**Smith Drive/Louisville Drive Traffic Calming**

Please see my attached markups of the preliminary plan set for the construction area. I am particularly concerned with the bulb outs and islands that force bicycles into the vehicle travel lanes. In addition, bicycle/stroller/wheelchair on- and offramps need to be provided to connect the sidewalks of the straight-through roads with the roadways on each side of all tee intersections.

**2021-11-18 Smith & Louisville Dr dwg Markups.pdf**

**SMITH DRIVE/LOUISVILLE DRIVE  
 TRAFFIC CALMING**  
 Smith Drive Plan Sheet - Louisville Drive to Dayspring Drive

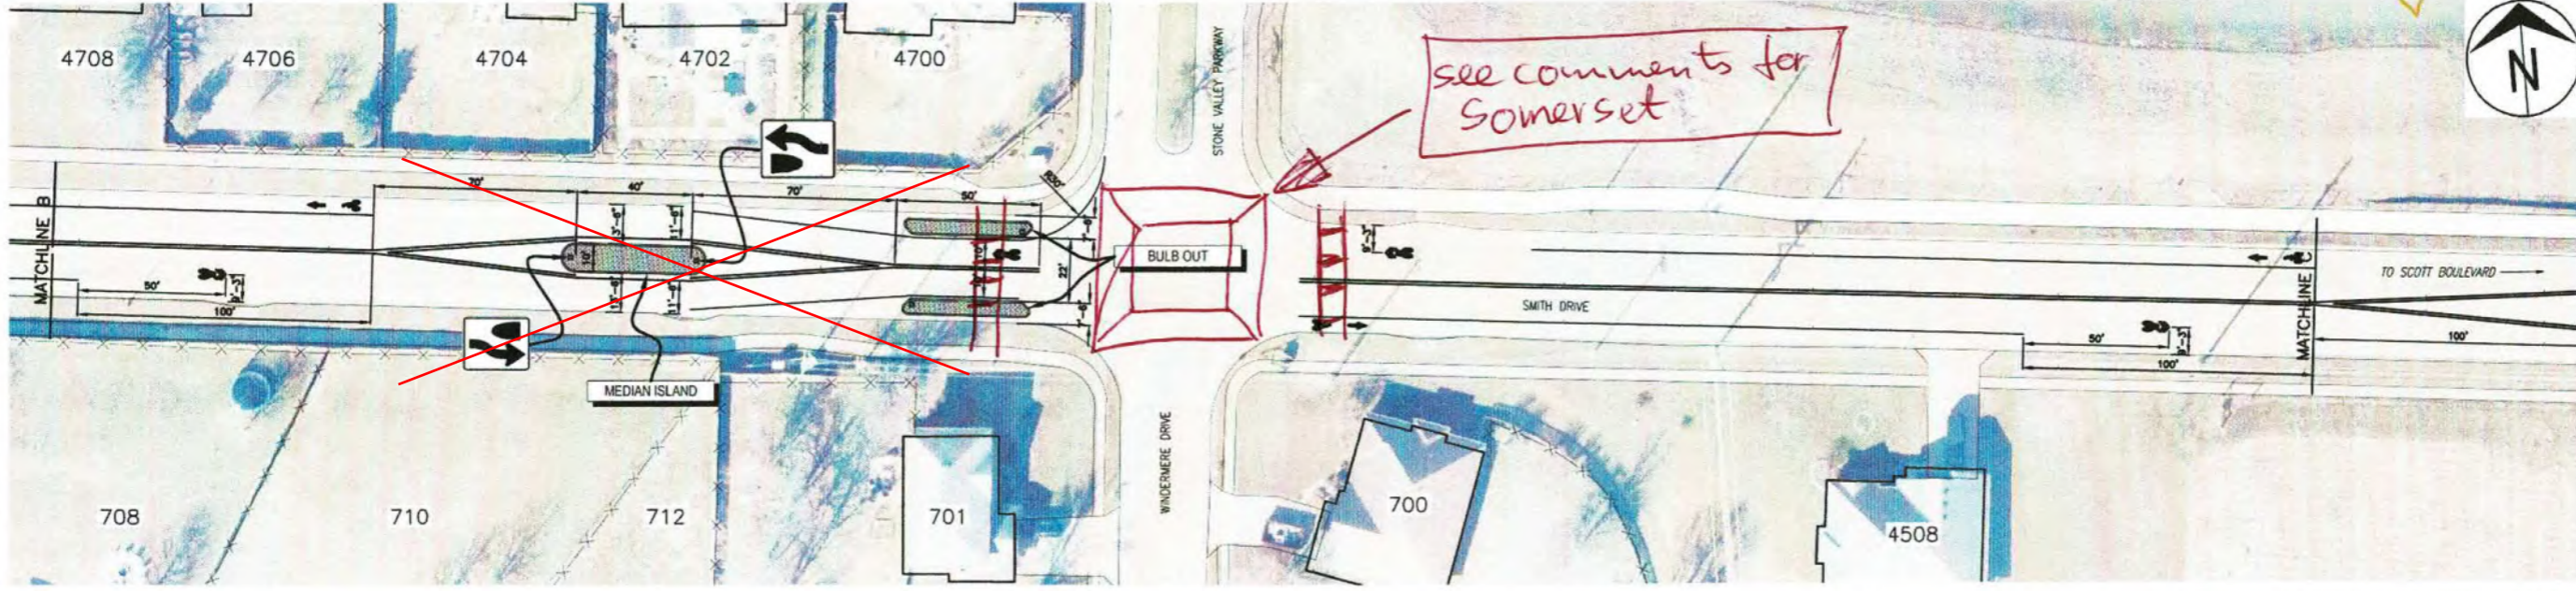
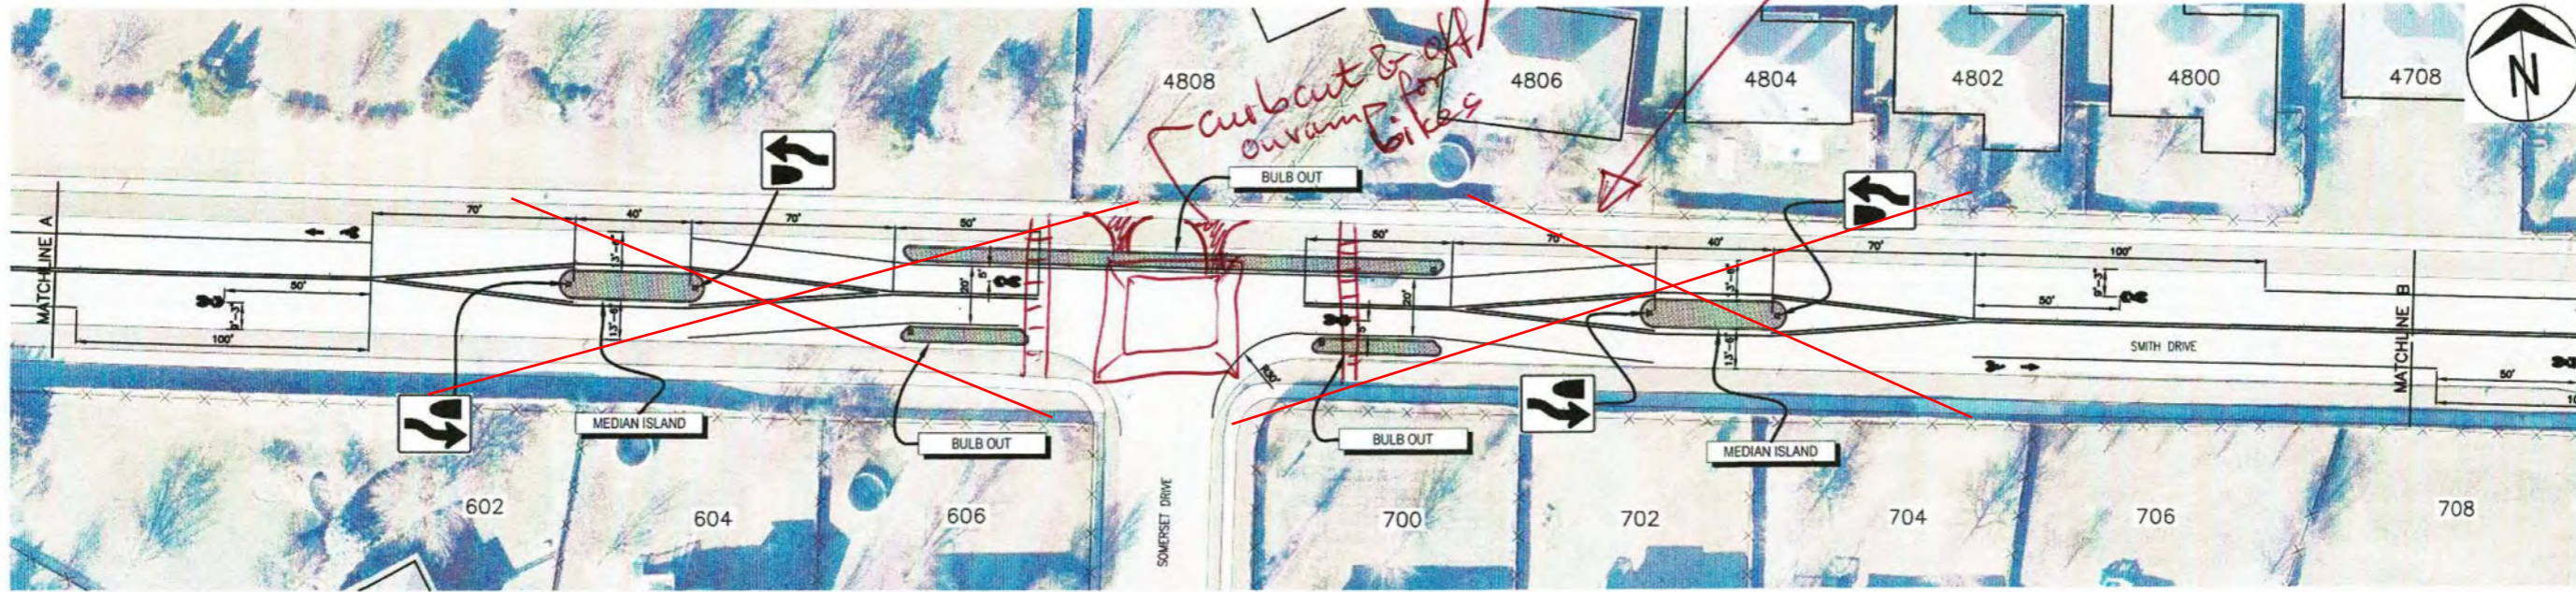
- This design forces bikes into the driving lane. 85% speed is >45mph → unsafe!  
 - Makes snow removal difficult  
 - Low visibility EB due to vertical curve  
 → Add Xwalks on Smith Dr. & Speed Table  
 Current design looks dangerous  
 - Also provide "off" for bikes to/from Somerset to N Smith Dr. SW

**SMITH DRIVE/LOUISVILLE DRIVE  
TRAFFIC CALMING**  
Smith Drive Plan Sheet - Dayspring Drive to Scott Boulevard

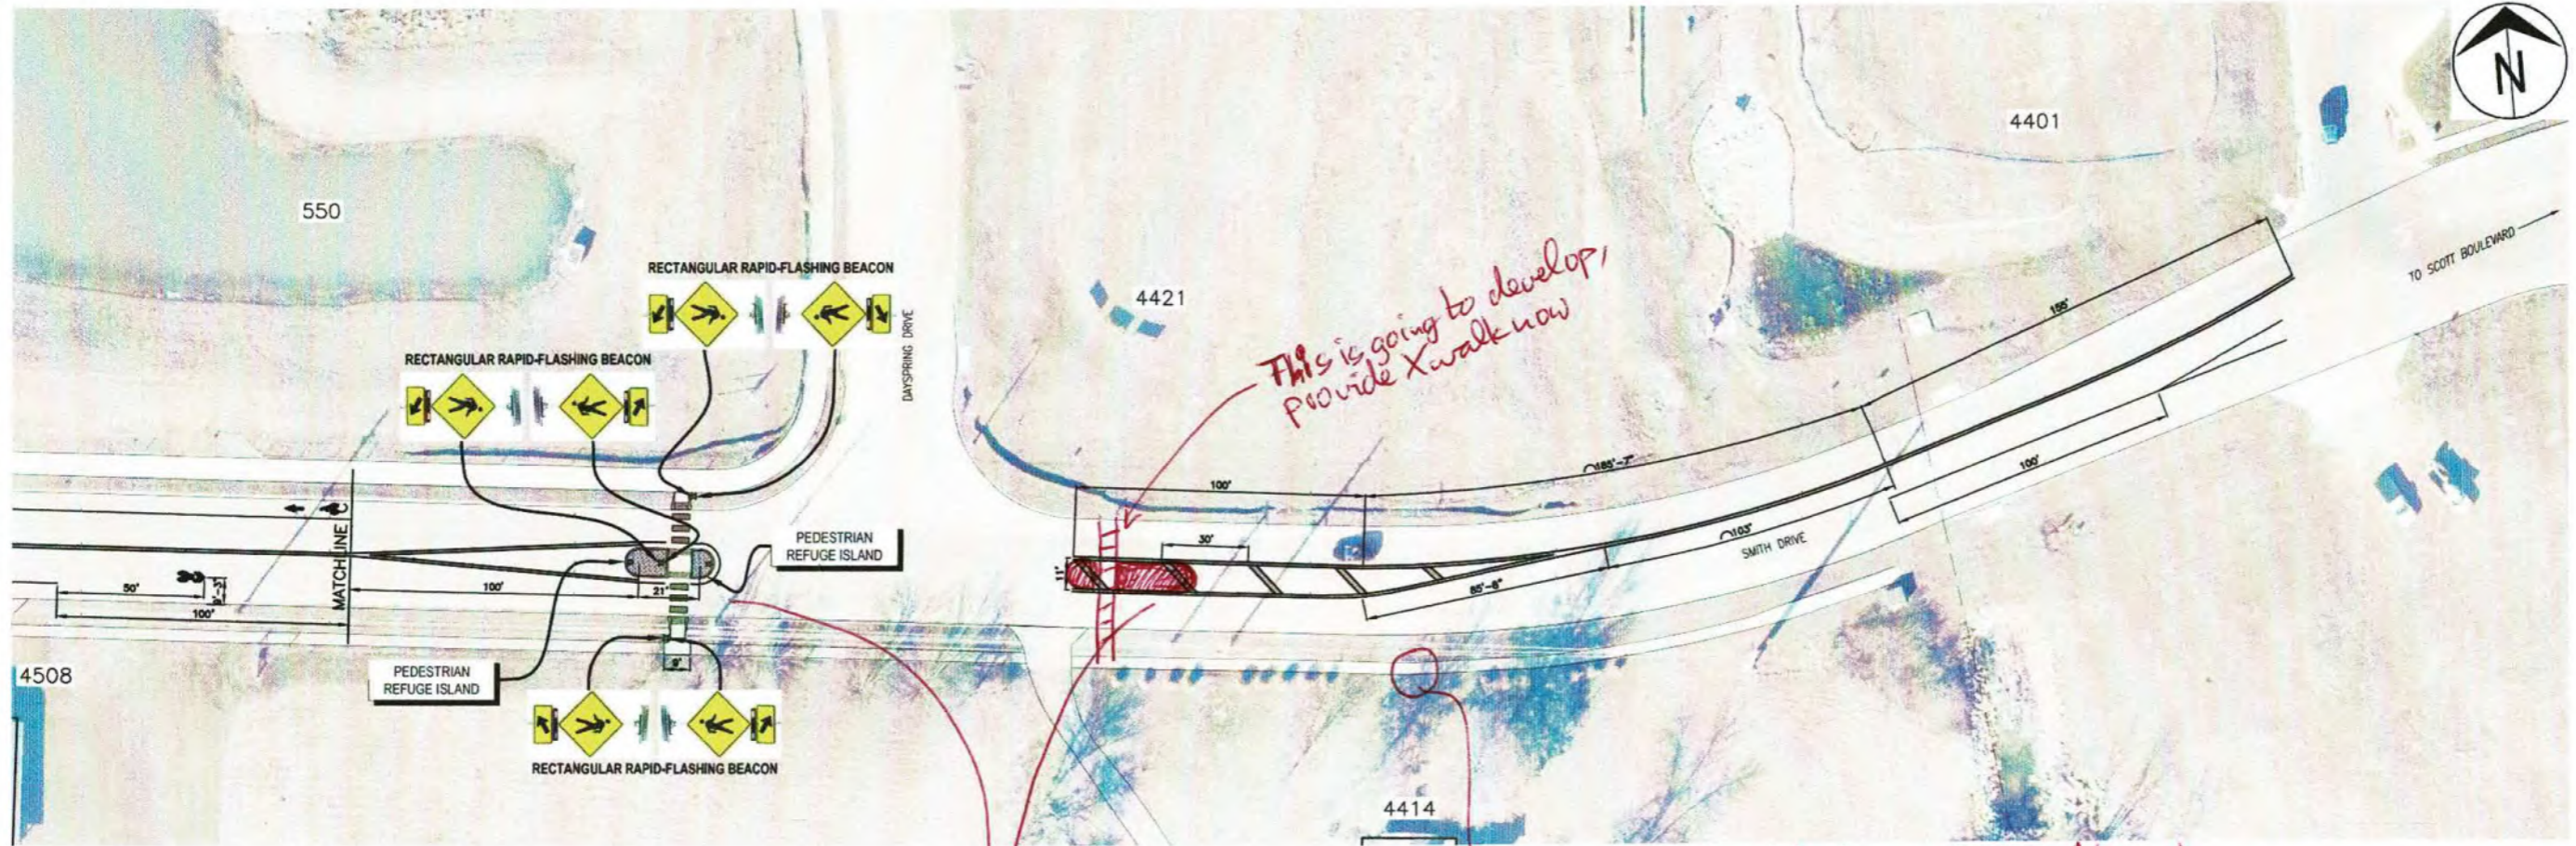
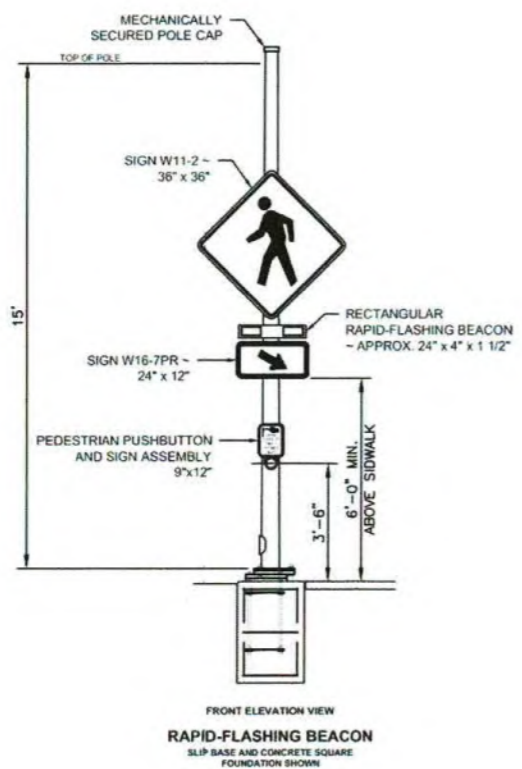
*This is going to develop, provide X walk now*

*consider straightening SW at dead tree stump*

*→ Narrow driving lanes as needed to stripe Bike paths to intersection. It is dangerous to merge w/ 45+ mph traffic.*

**LOUISVILLE DRIVE — RAINBOW TROUT DRIVE**  
1" = 20'

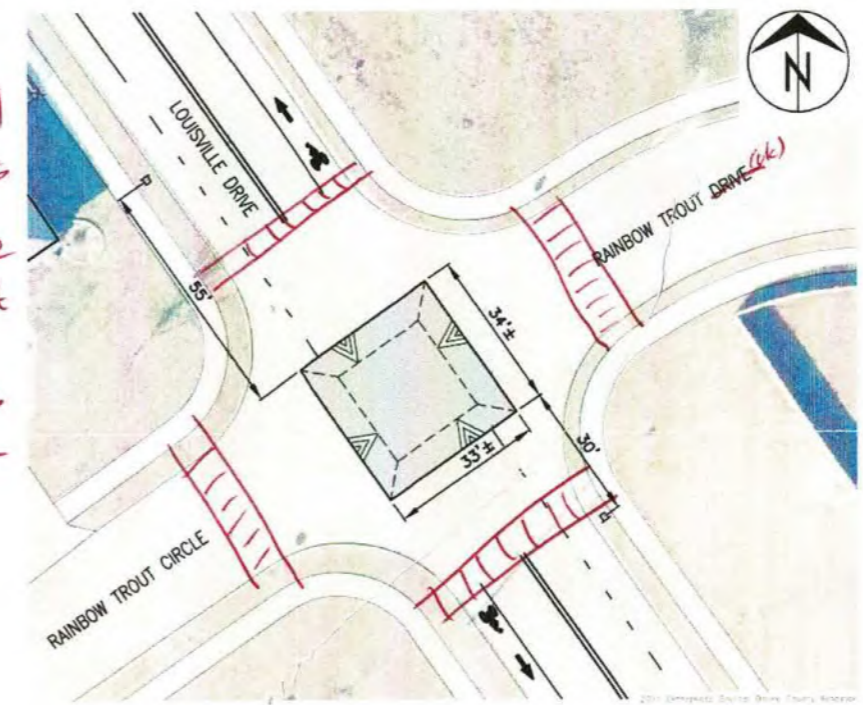
*Add 4  
Xwalks  
both Louisville  
& Rainbow Trout  
Dr. ave  
cut-throughs  
in dense neigh-  
borhood*

LOUISVILLE DRIVE — RAINBOW TROUT CIRCLE  
1" = 20'

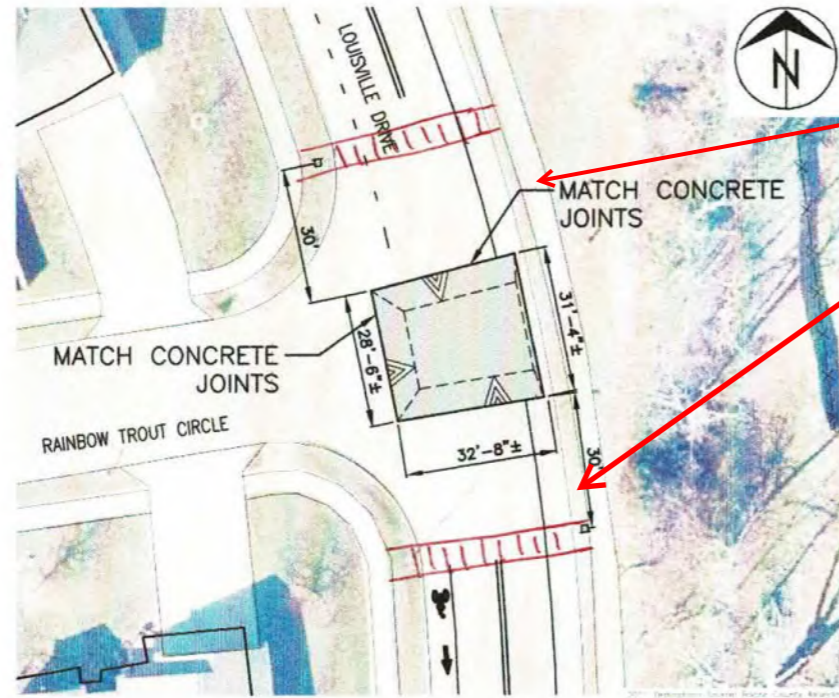
Visibility an issue due to horizontal curve → add Xwalks

LOUISVILLE DRIVE — LABRADOR DRIVE  
1" = 20'

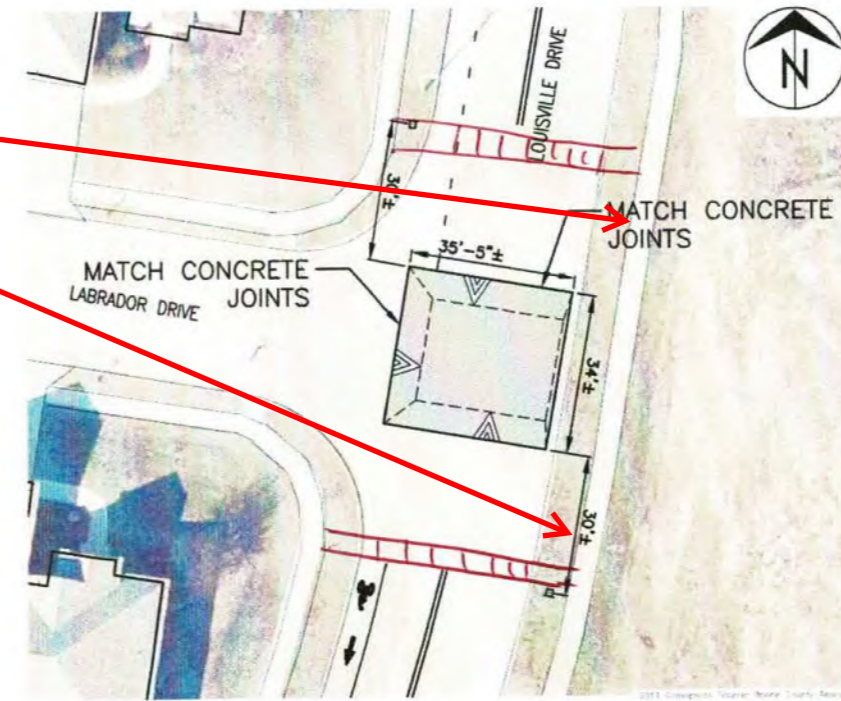
Add bike on/off ramps to SW. Not needed if Xwalks are constructed.

LOUISVILLE DRIVE — TIPTREE COURT  
1" = 20'

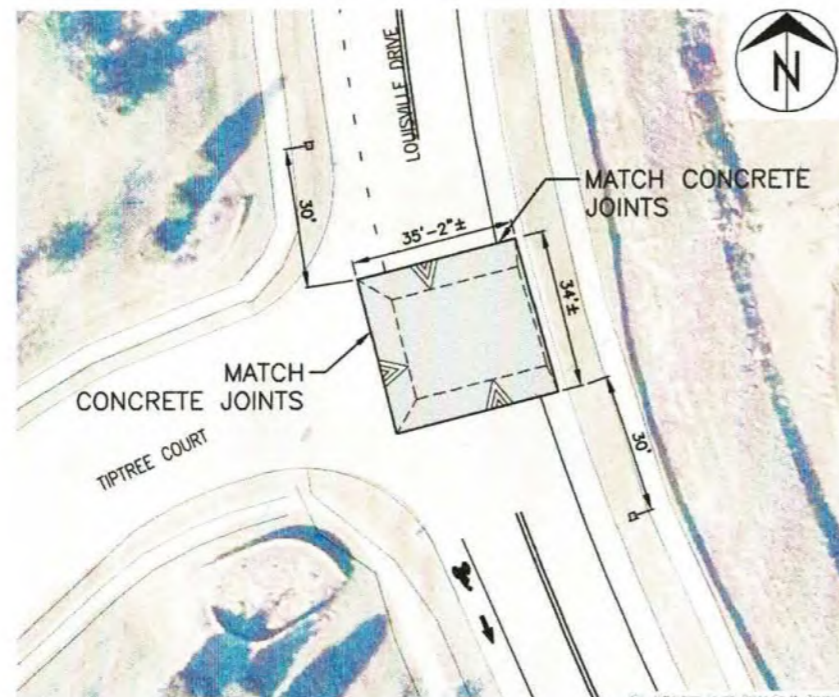
Low visibility due to vertical curve → add Xwalks
